MISSION TRAIL COMMUNITY LIBRARY WILDOMAR, CALIFORNIA

TITLE SHEET

AS-BUILT

SINGLE LINE DIAGRAM

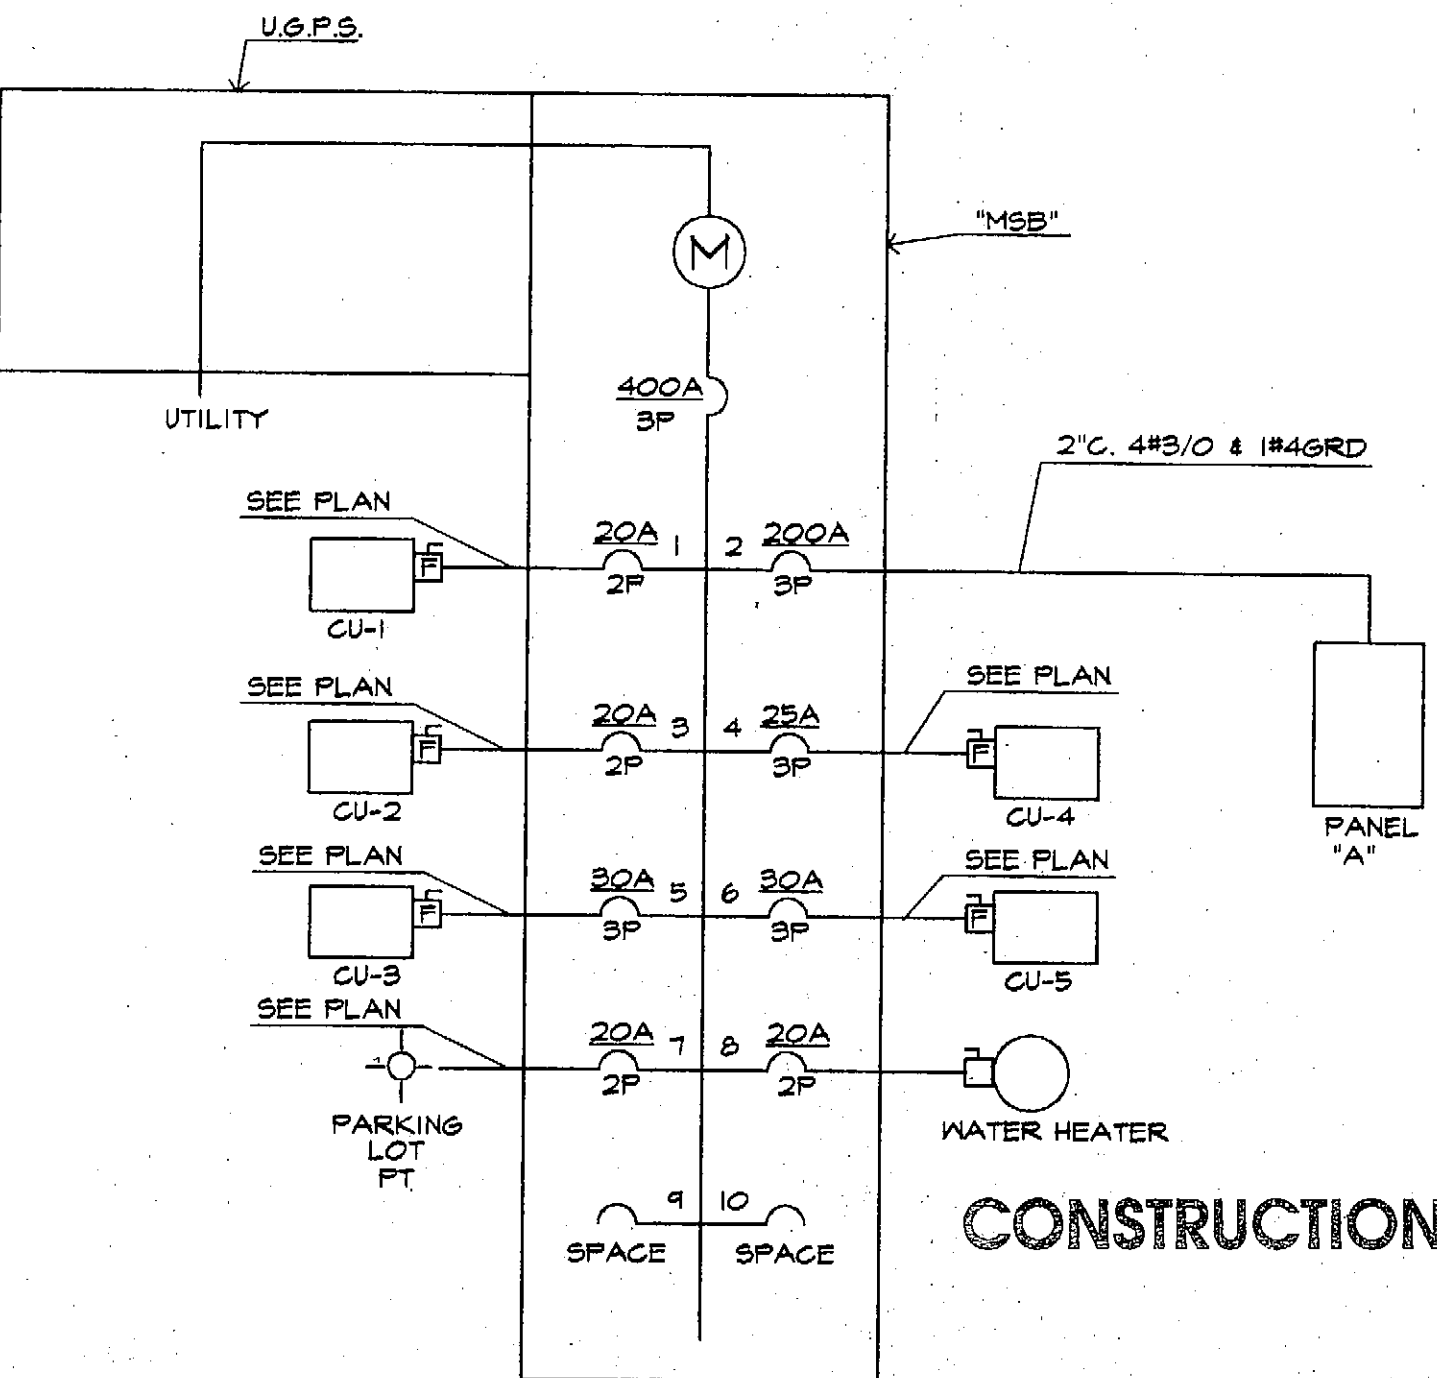
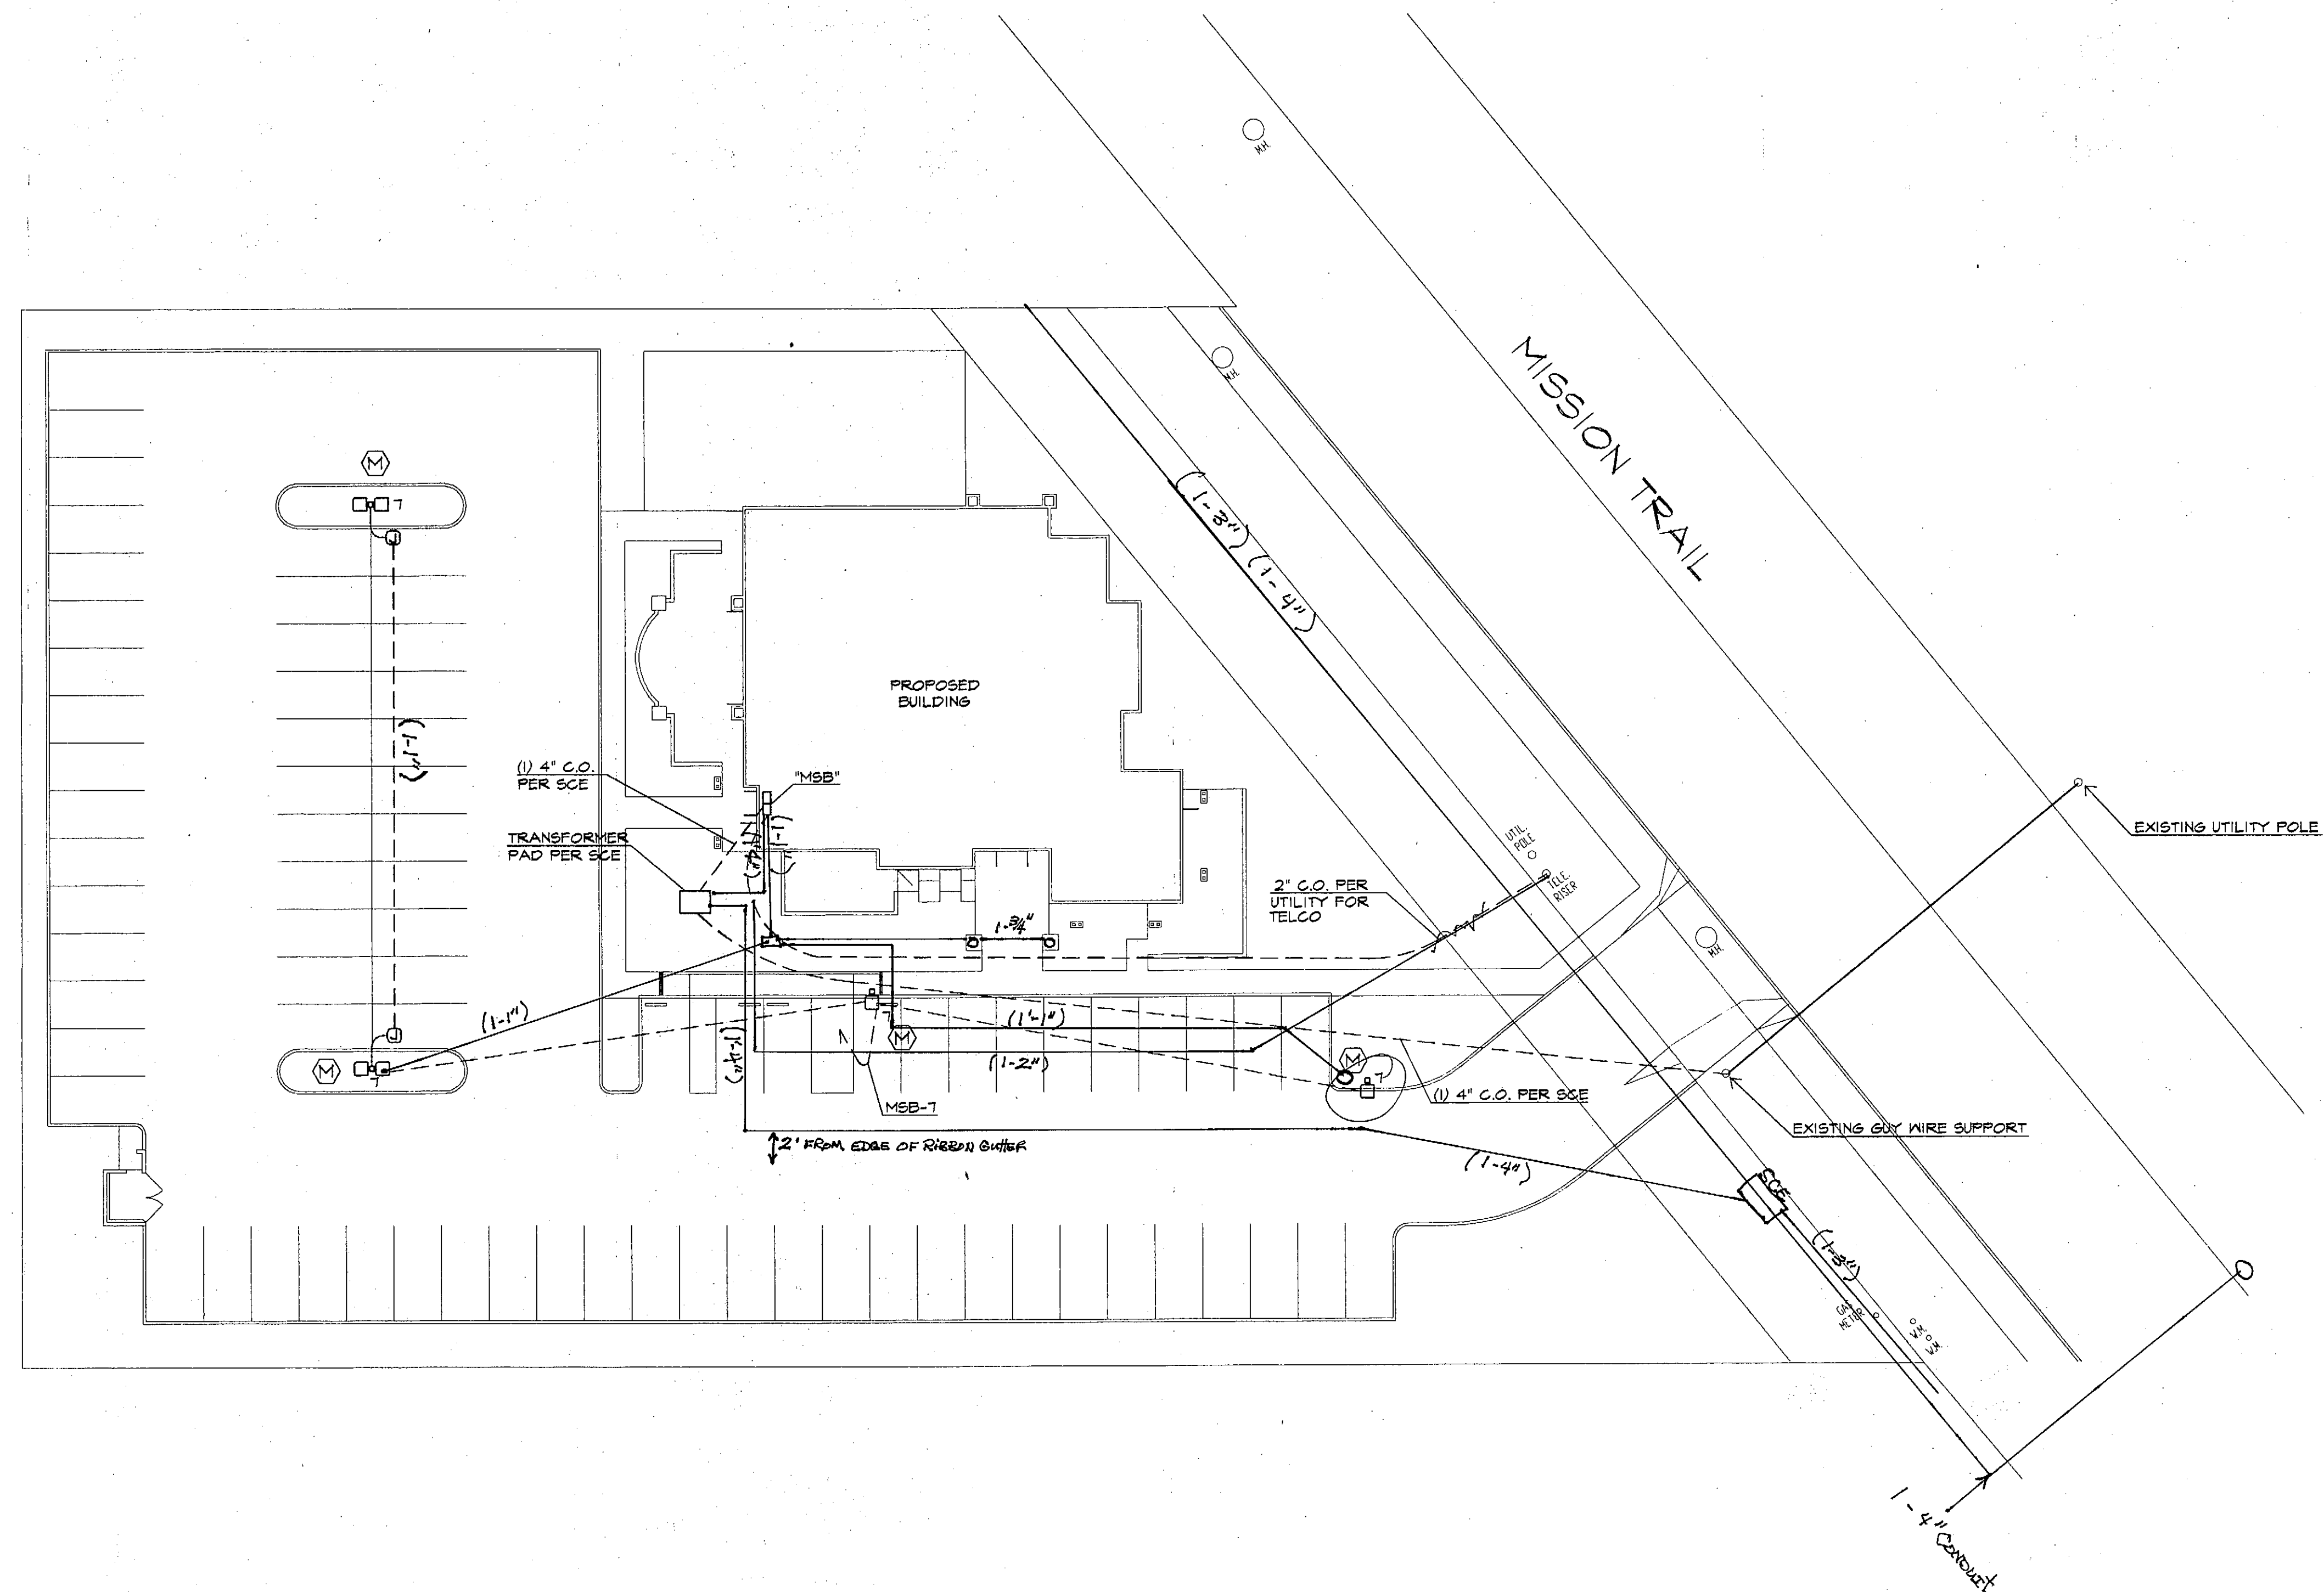
ADD Fire Alarm for 21
Security

(DEMOLITION)
PARTIAL FLOOR PLAN
SCALE: 1/4" = 1'-0"

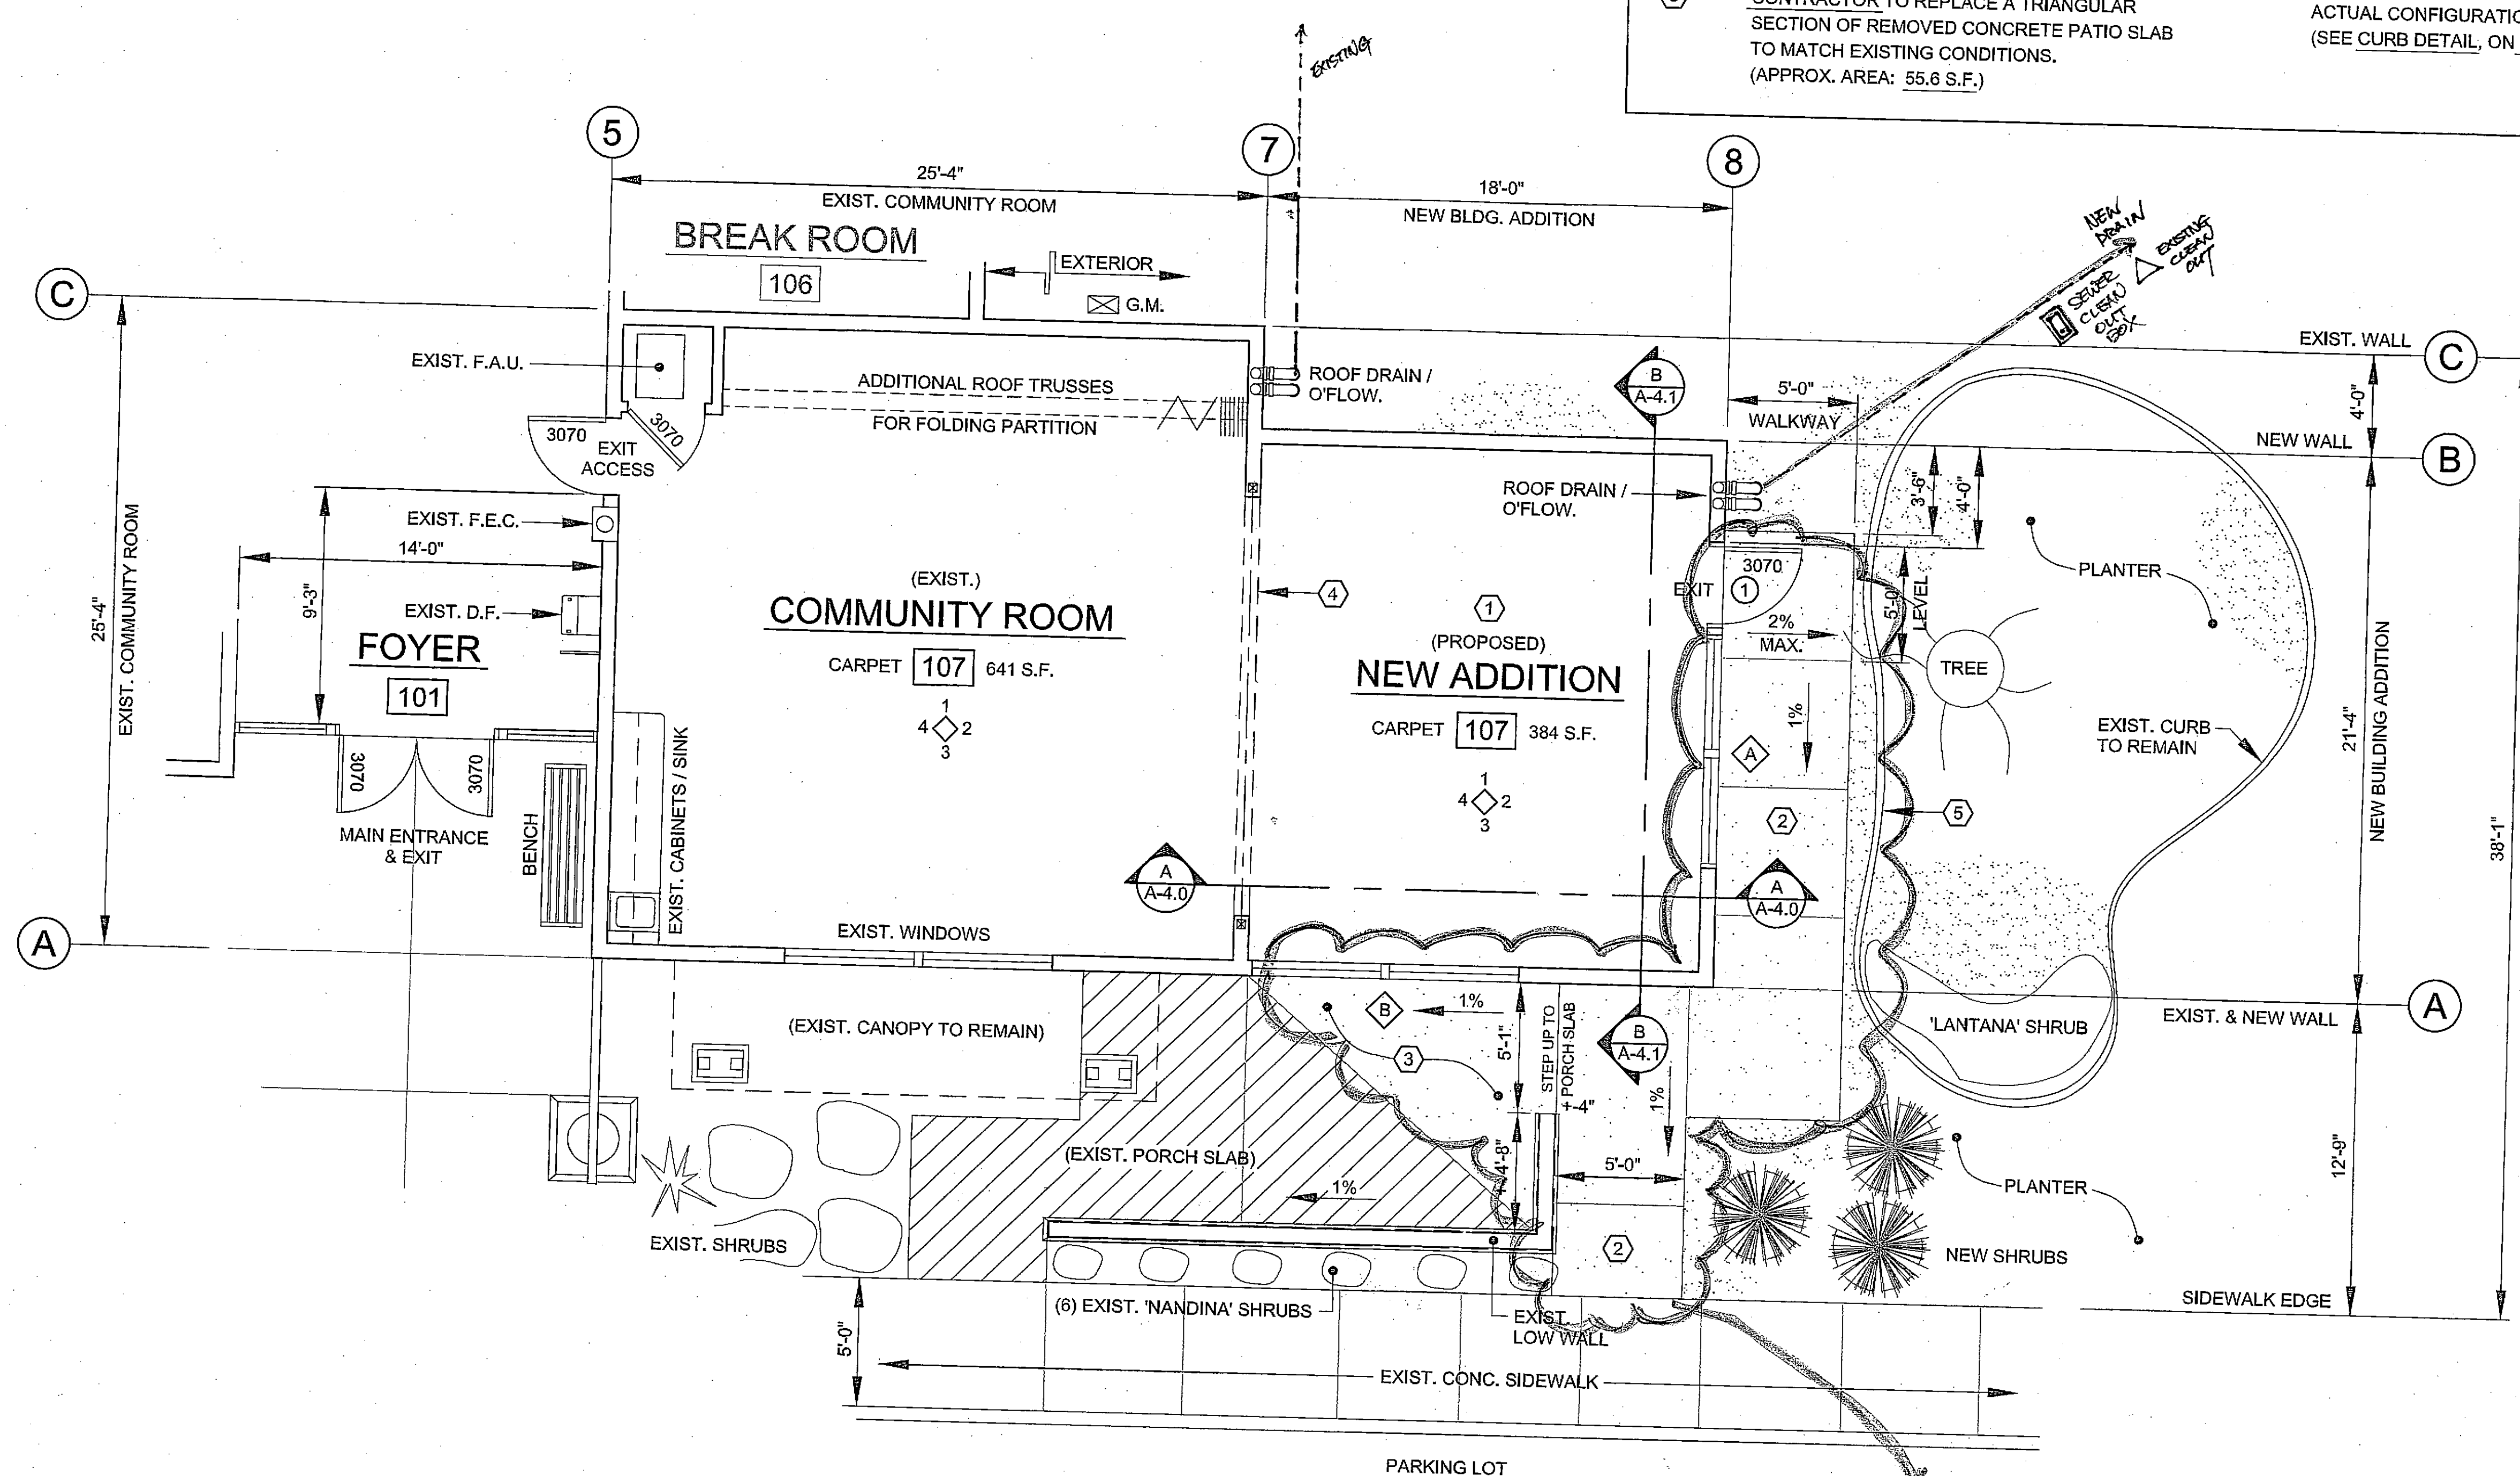
RFI #21
SIDE WALK
